Work Order ID 136217

Item Name: Support

WORK ORDER NON-CONFORMANCE / UPDATE

From: Pablo Bravo
Sent: September-10-15 8:45 PM
To: Jean-Luc Menard
Subject: RE: 646.3210 DEVIATION?

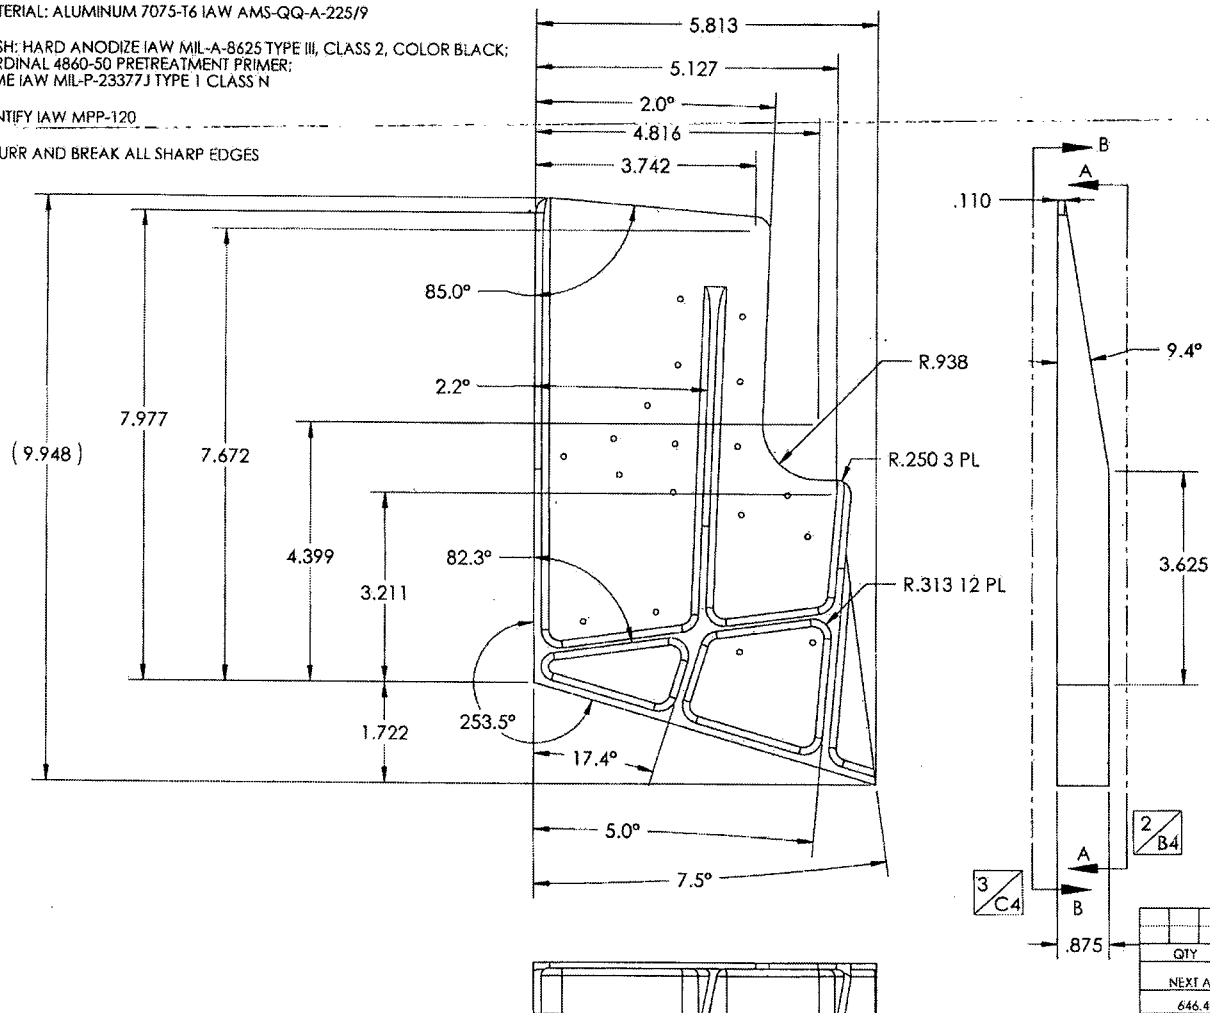
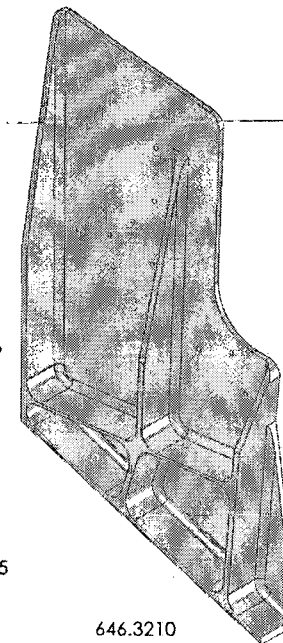
- 0.875 ± 0.005 under tolerance on 6 pieces
 - Measure is at 0.867 "

Re → did not set off-set on Machine
 Right For 0.875 ± 0.005 "

Hi Pablo,
Got some parts coming in at .867" thk instead of .875" +/- .005".
Is this acceptable?
Let me know,
JL

ACCEPTABLE PER ATTACHED Email
 between SLM & Polko.

This should be acceptable.
